Public Submission
on the
Proposed Development
of the
Beverley Uranium Deposit
by Heathgate Resources Pty Ltd
(aka General Atomics)

Gavin Mudd

**Public Submission on the Proposed Development of the Beverley Uranium Mine
by Heathgate Resources Pty Ltd (aka General Atomics)**

Figure 1 - Nine Mile Lake - Vanadium Concentration Trends
 (Nigbor et al., 1982 - note, it is believed the use of ppm is incorrect, should be ppb)

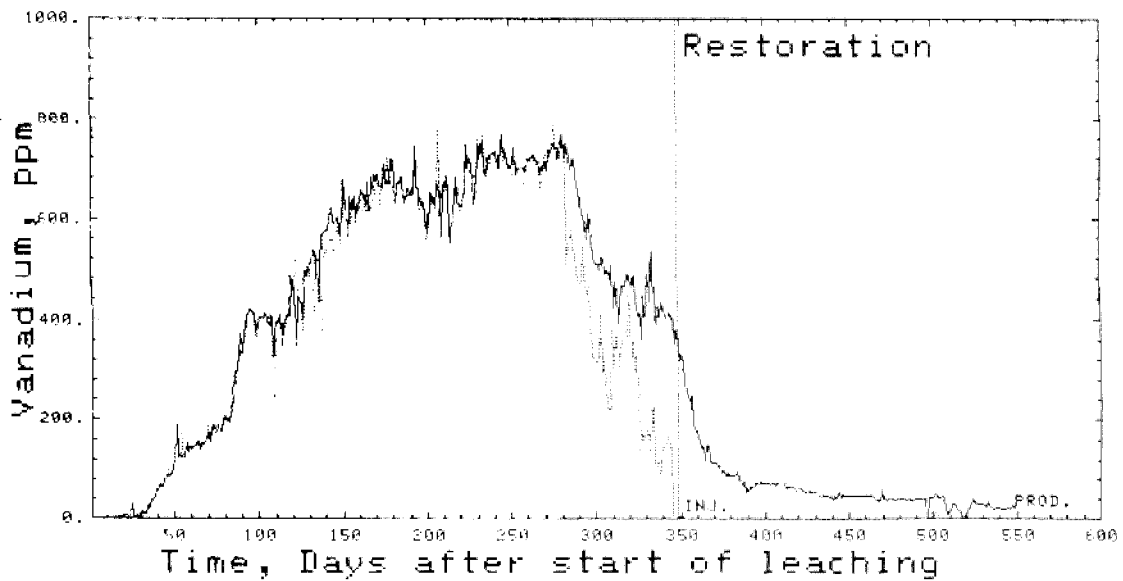
- the Nine Mile Lake FLT of acid ISL showed marked concentration of many toxic metals over time due to recycling of the leach solutions;
 - no mention is made of the different toxicity of the chemical form of many species, such as Chromium VI (valence state 6+), which is much more acutely toxic than Chromium III (valence state 3+) - the highly oxidised state of extracted leach solutions would arguably contain chromium in the more soluble and toxic 6+ state, for example (Fetter, 1993);

- the units of Molybdenum (Mo in µg/l) appear to be incorrect;
- no RADON or THORIUM is presented !!!!!**

Figure 2 - Willawortina Monitoring Failure

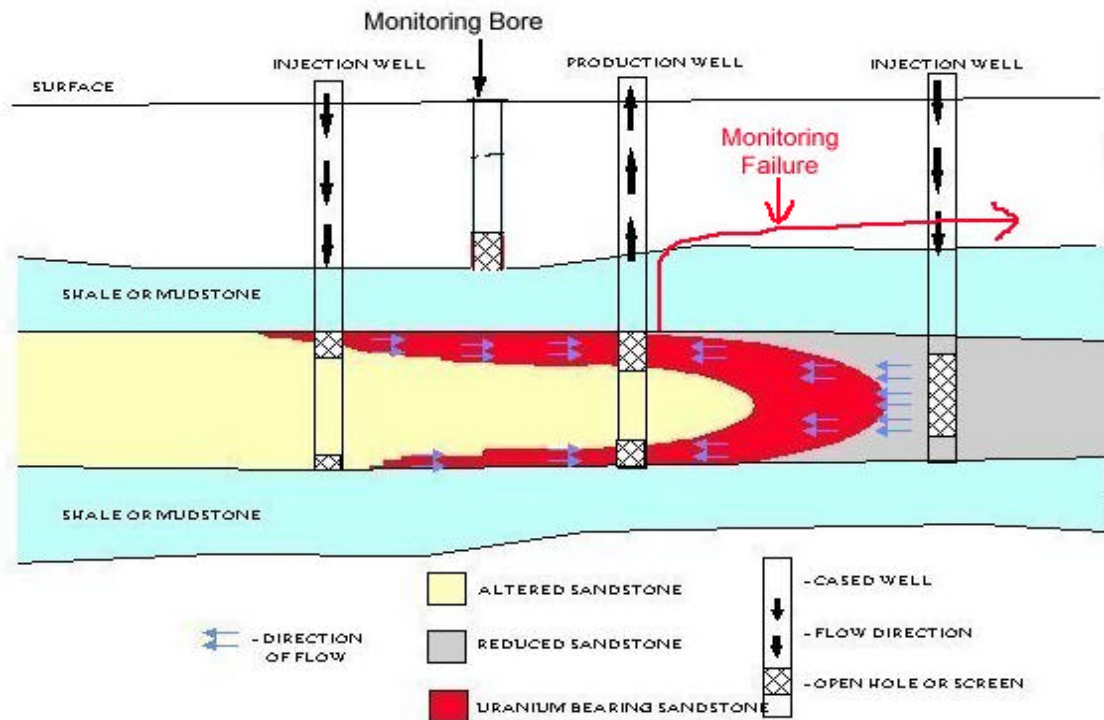
The wellfield schematic presented in Figure 4.8 does not represent good monitoring and could very easily not detect an excursion :

- due to the known anisotropic behaviour of palaeochannel aquifers, the ore zone monitoring wells may not be spaced close enough to detect an excursion, especially if such an excursion were to occur in a subchannel of the wider palaeochannel (refer Figure 16; Mudd, 1998a);

SURFACE PIPES WON'T CRACK WITH WEATHERING, EXPANSION AND CRACKING ?
